Our Ref: 8798  
Council Ref: A004942635

**RE: RESPONSE TO INFORMATION REQUEST  
SECTION 13.2 OF THE DEVELOPMENT ASSESSMENT RULES  
162 OCEANA TERRACE, LOTA (LOT 62 ON RP839534)**

**Figure 3:** Level 1 Proposed Site Layout (Source: S3 Architects)

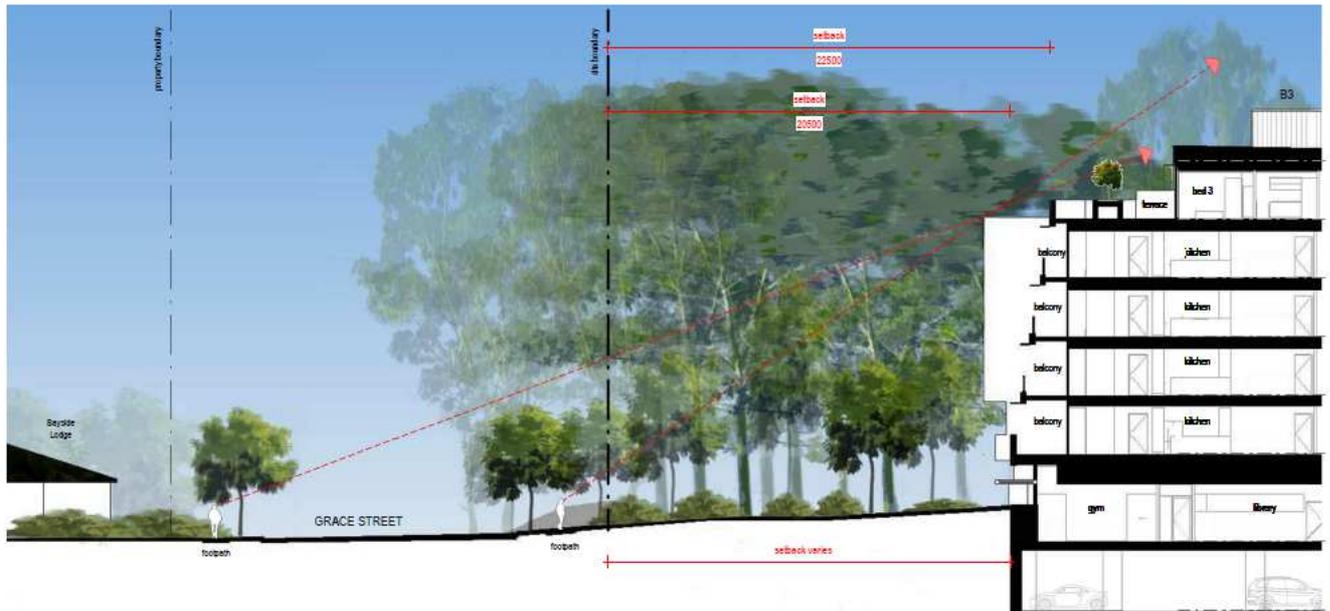
With regard to building siting and orientation, the proposed development incorporates substantial setbacks to street frontages and significant separation distances to the heritage residence, Lota House. The minimum setback to Oceana Terrace is proposed at 7.1 metres (Building 1 – Level 1) with the minimum setback to Grace Street being 14.6 metres (Building 4 – Level 1). Increased setbacks to street frontages were incorporated from the pre-lodgement design phase to allow for retention of significant vegetation and the existing woodland. In addition to ensuring preservation of existing vegetation (one of several community concerns raised in submissions), retention and significant rehabilitation of vegetation is now proposed which will aid in additional screening of the proposed development from street view and surrounding development.
